Addendum No. 1

Subject: BLANKENBURG ELEMENTARY SCHOOL
NEW CAFETERIA AND KITCHEN
SDP CONTRACT NOS. B-060 C, B-061, B-062, B-063 C OF 2020/21

Location: BLANKENBURG ELEMENTARY SCHOOL
4600 W. GIRARD AVENUE,
PHILADELPHIA, PA 19131

This Addendum, ***dated 26th of February, 2021***, shall modify and become part of the Contract Documents for the work of this project. Any items not mentioned herein, or affected by, shall be performed strictly in accordance with the original documents.

DRAWING NO.
A400

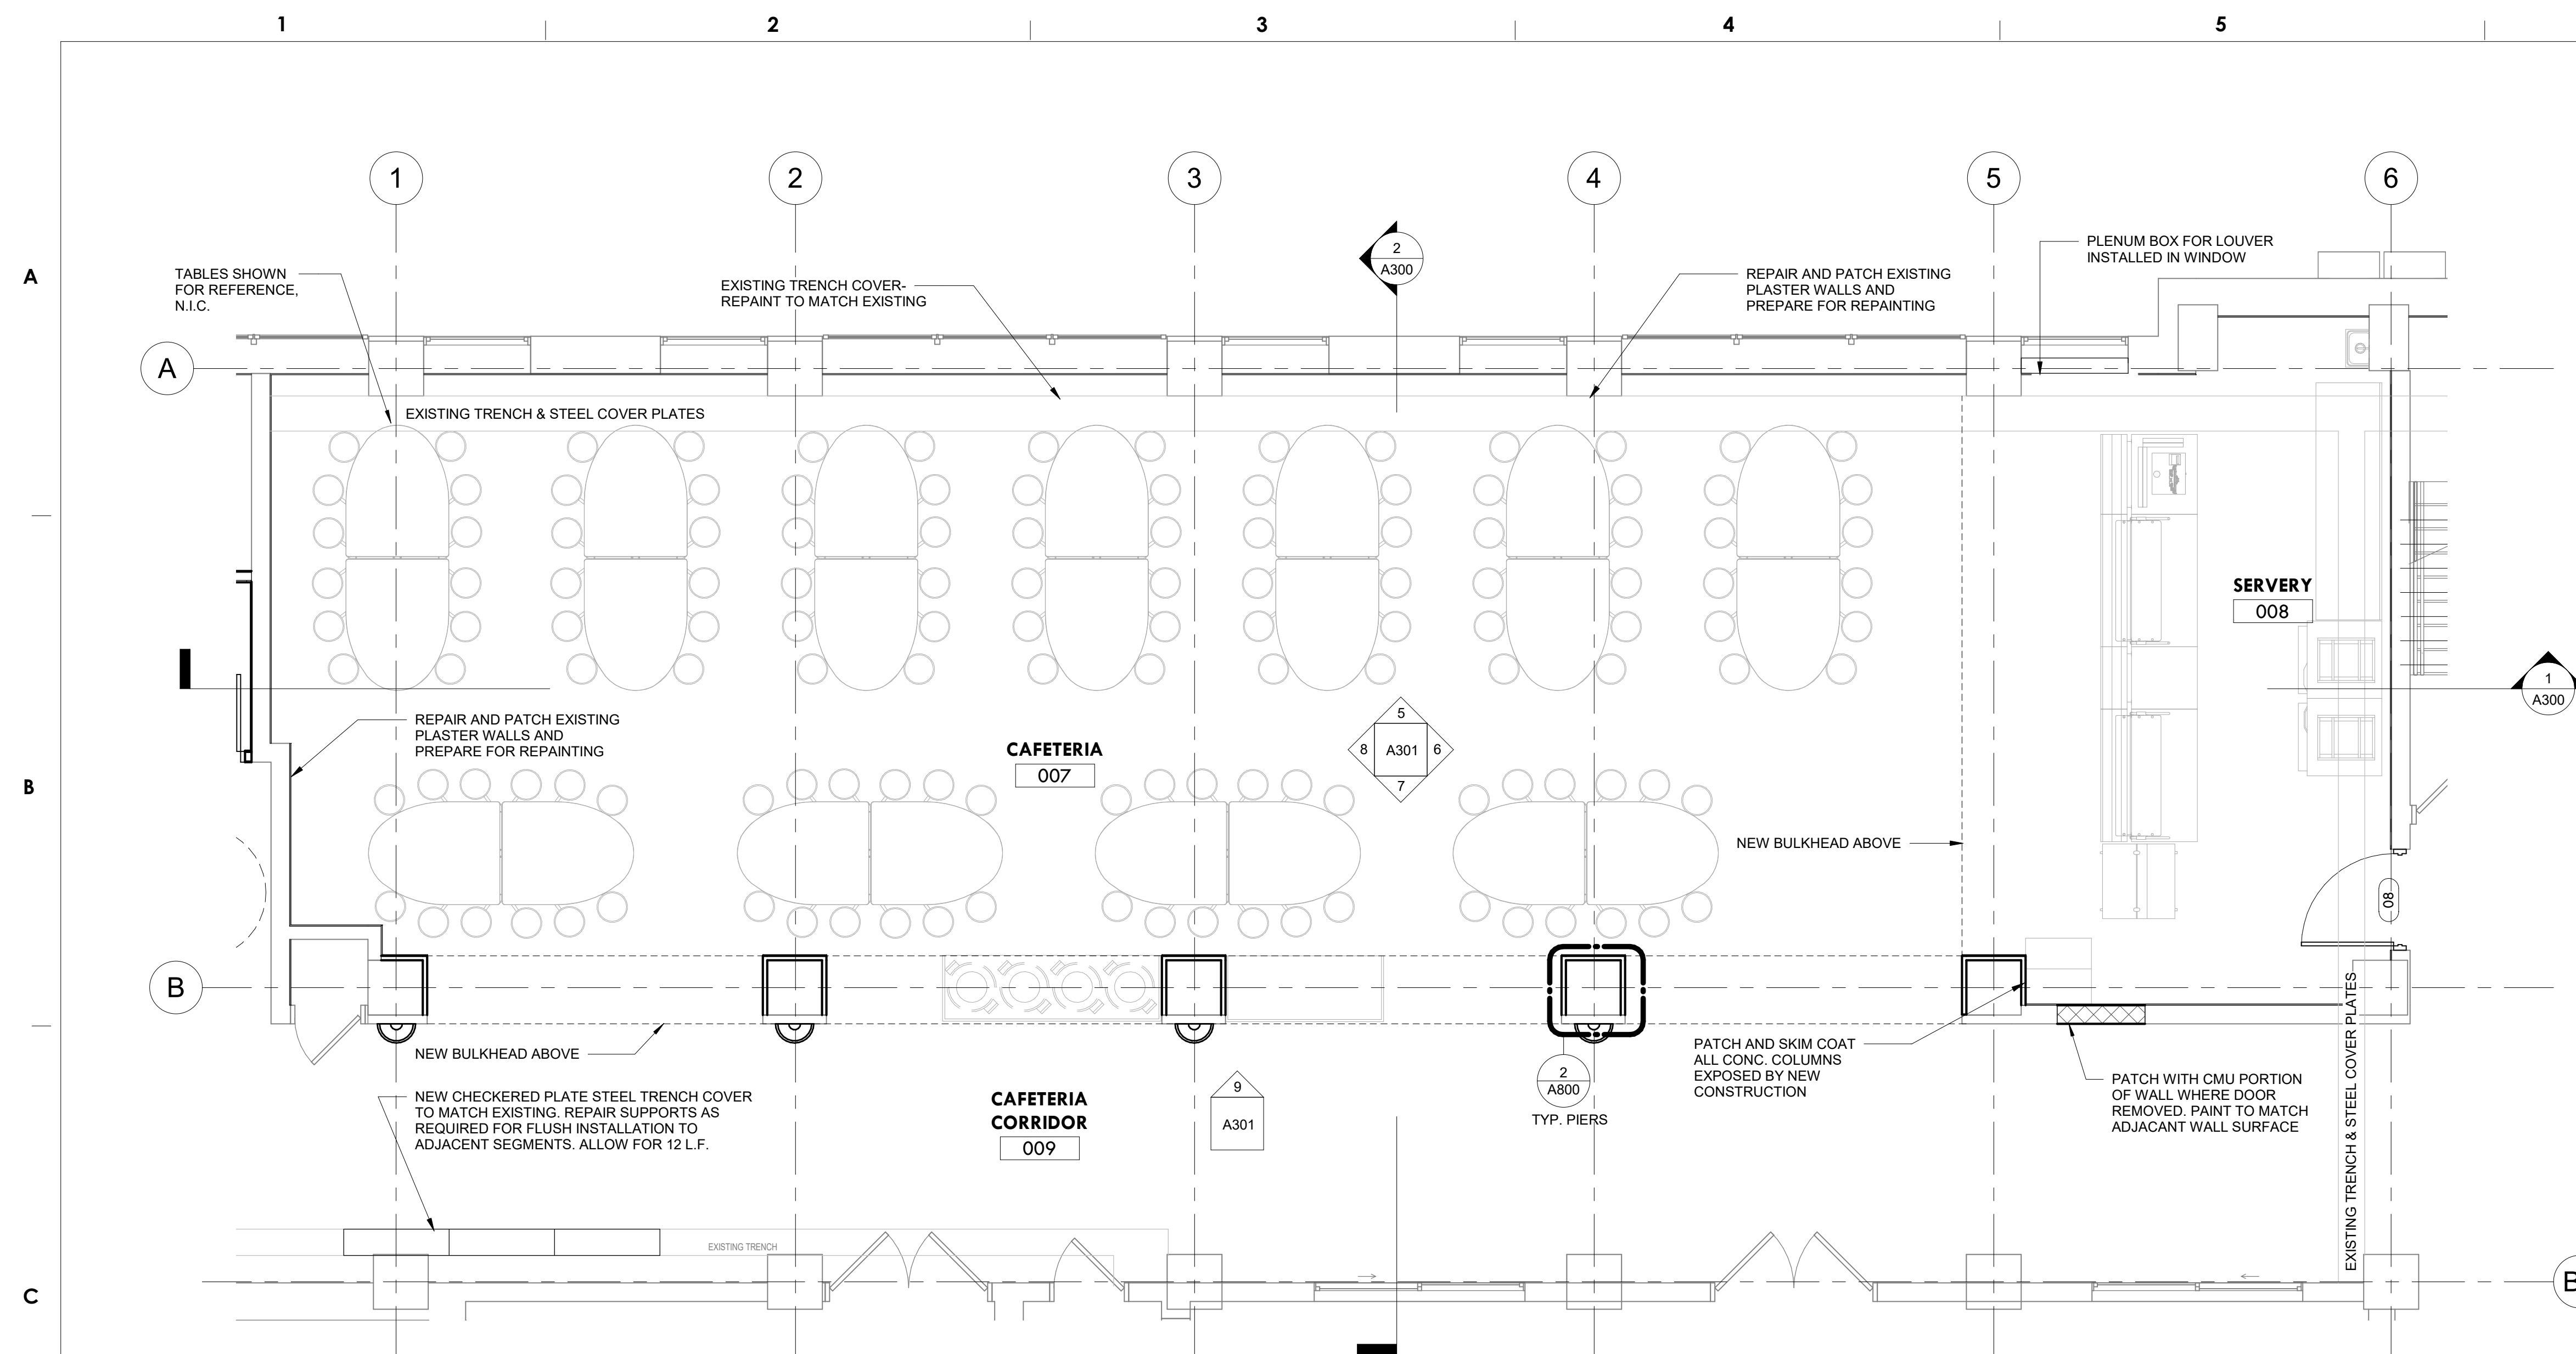
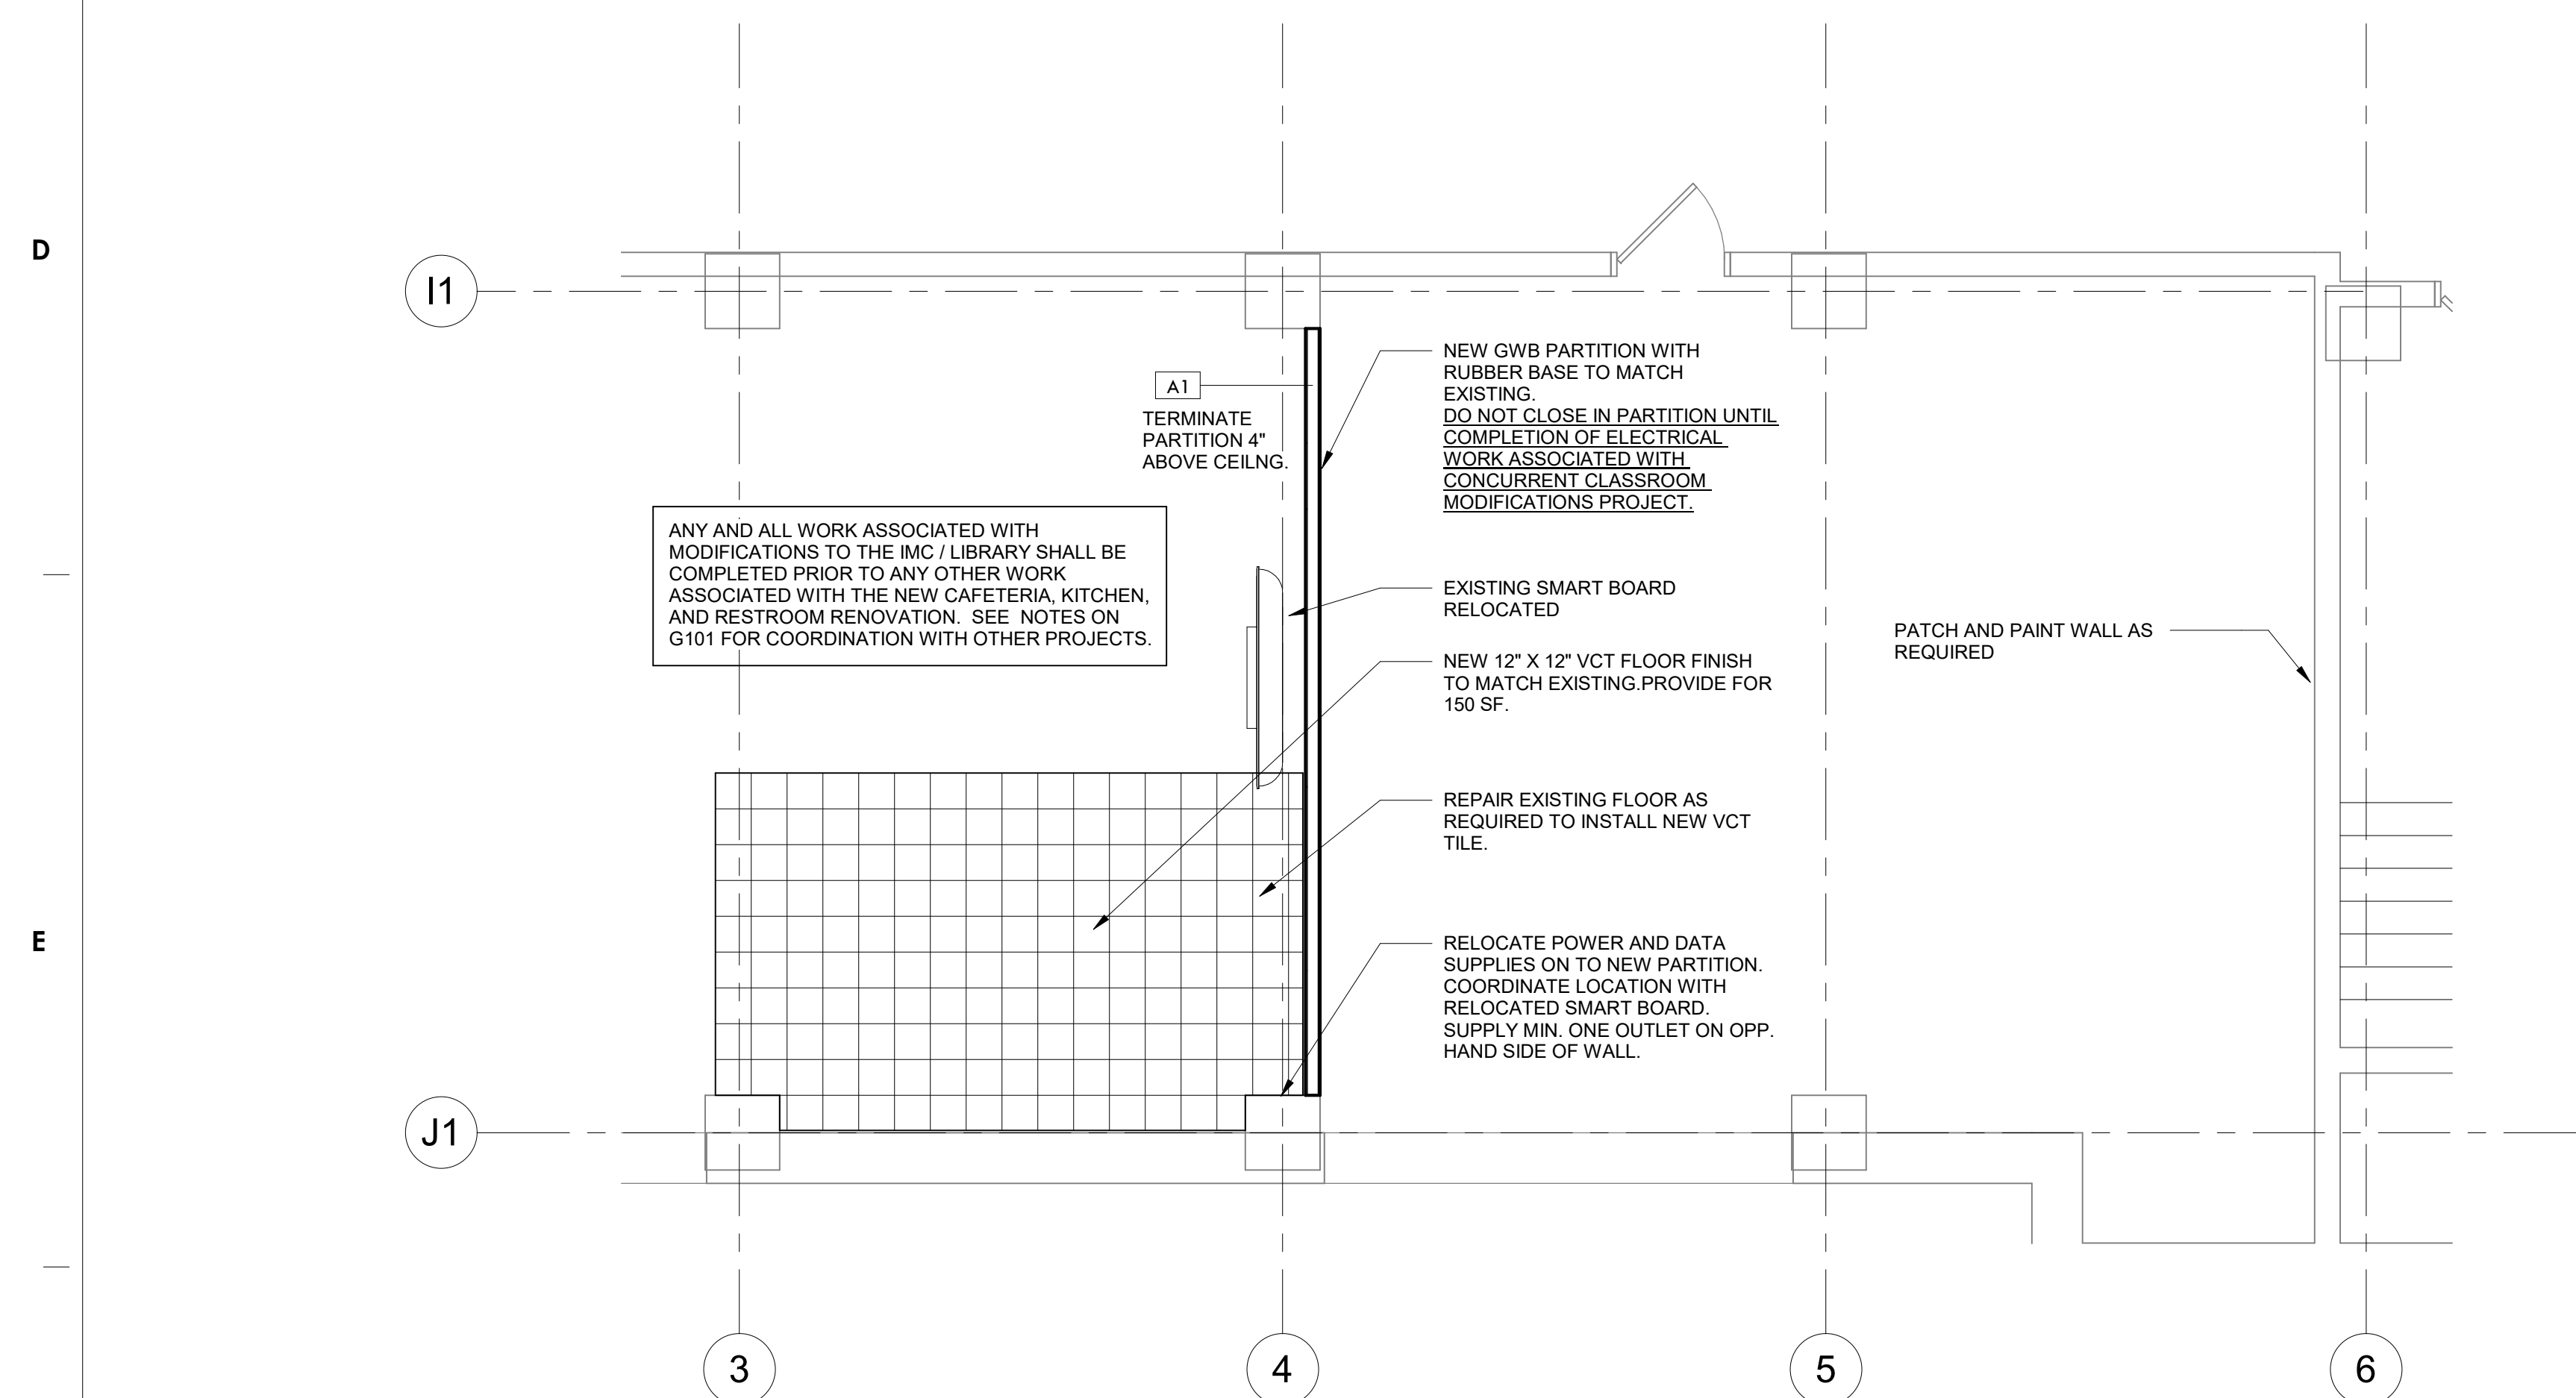
1. See attached photo of cabinets with this addendum.
 - c. Drawing A400:
 - i. Revised notes on plan at Room 31 (library / IMC).
 - d. Drawing FA000:
 - i. Revised fire alarm drawing.

DRAWING NO.
FA000
SHEET 03 OF 44

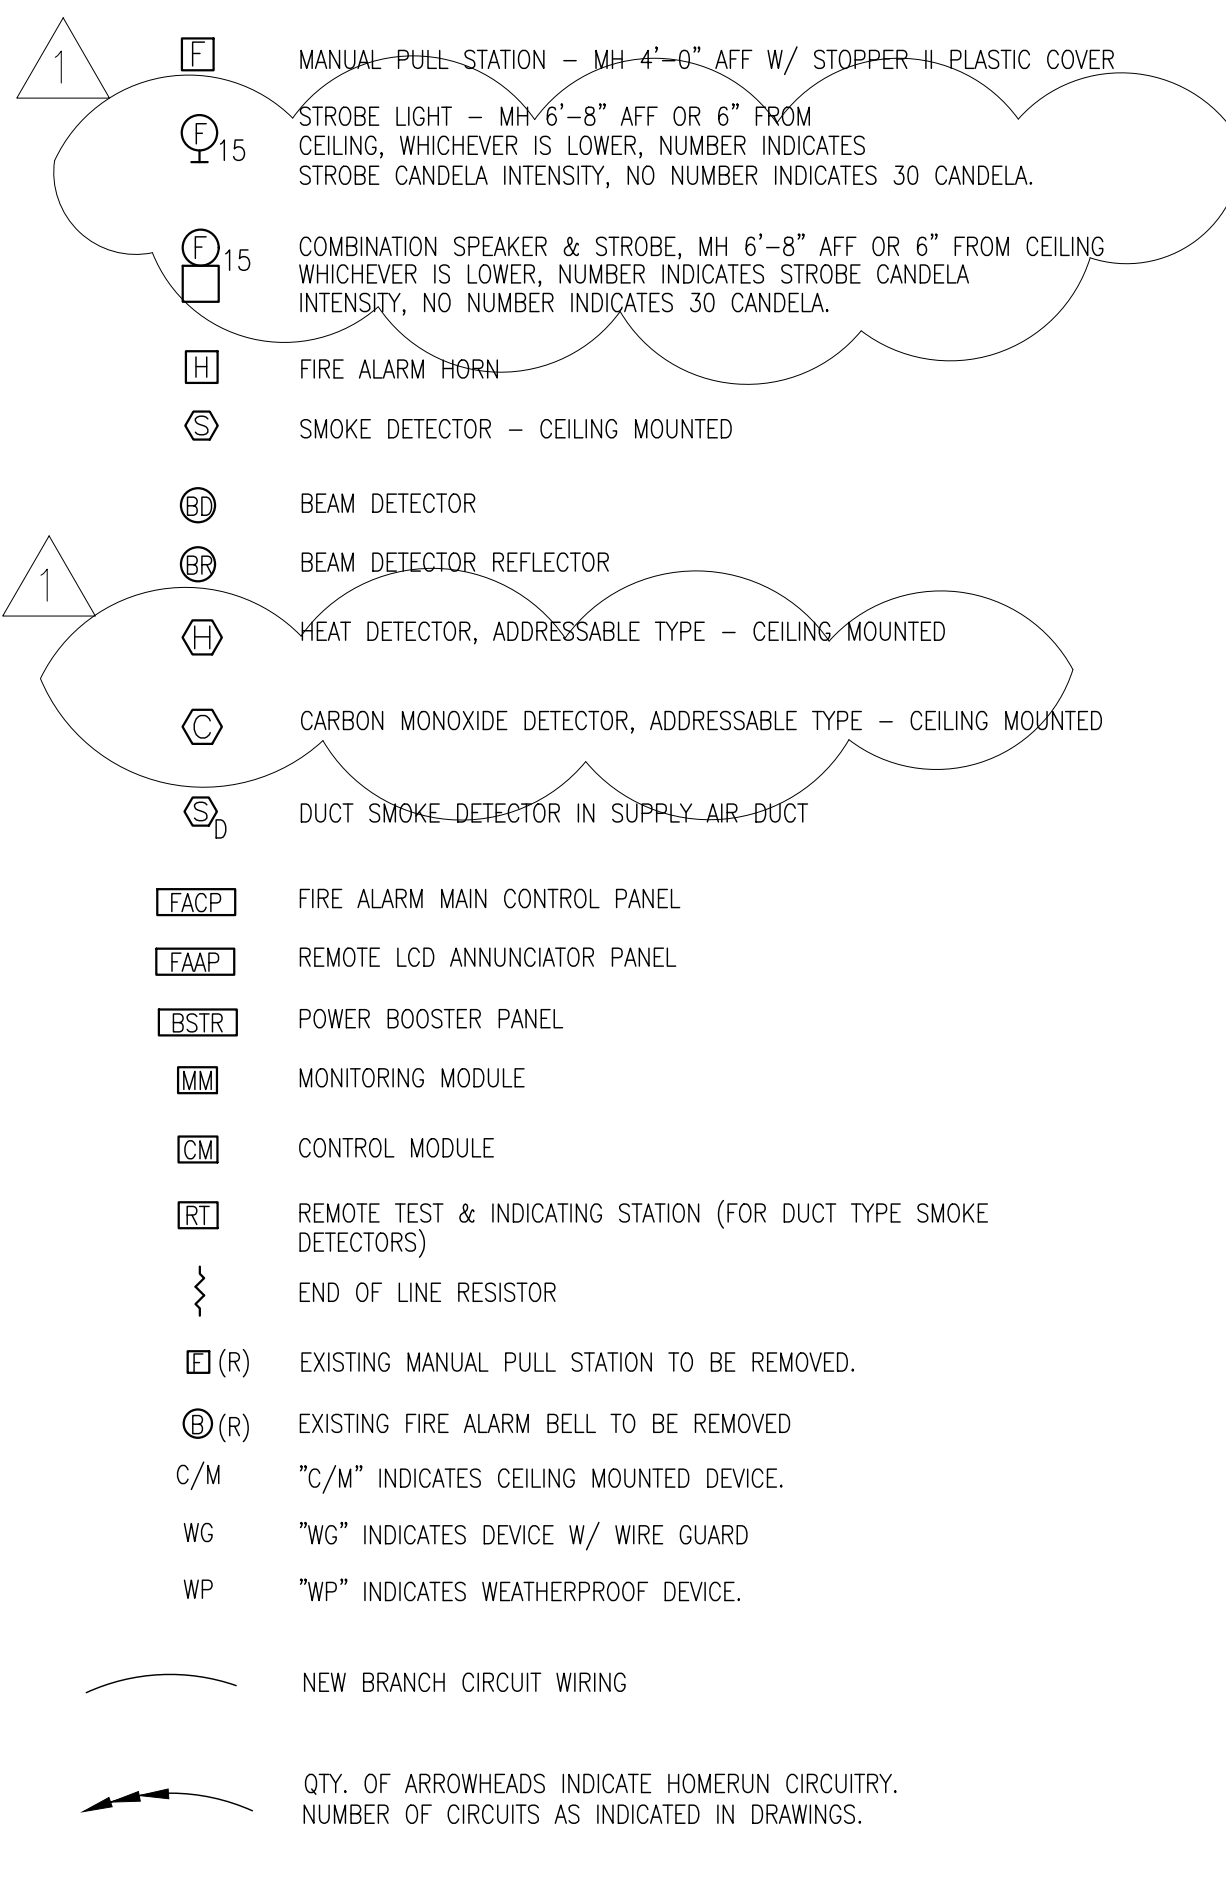
6. There are initiating device symbols on the fire alarm floor plans that are not indicated in the symbols list on FA000. It is unclear what type of audible initiating device should be provided (speaker? Horn?). Does the existing system have voice capability or not? Please provide an updated symbols list that reflects the existing system and includes all symbols shown on the plans.

- a. Provide DACT for the new fire alarm installation.
8. Please confirm general note 3 on FA000 ("provide a new addressable fire alarm system") is **not** applicable to this project, as the fire alarm plans indicate that we are connecting to an existing fire alarm system.

- a. The audible device shall be a speaker. Existing system does not have voice capability. Symbol list has been updated and revised drawings and specifications attached.

- a. The new Fire alarm system shall be a voice enabled addressable system. Refer to attached revised drawings (FA000, FA100, FA102) and specifications.
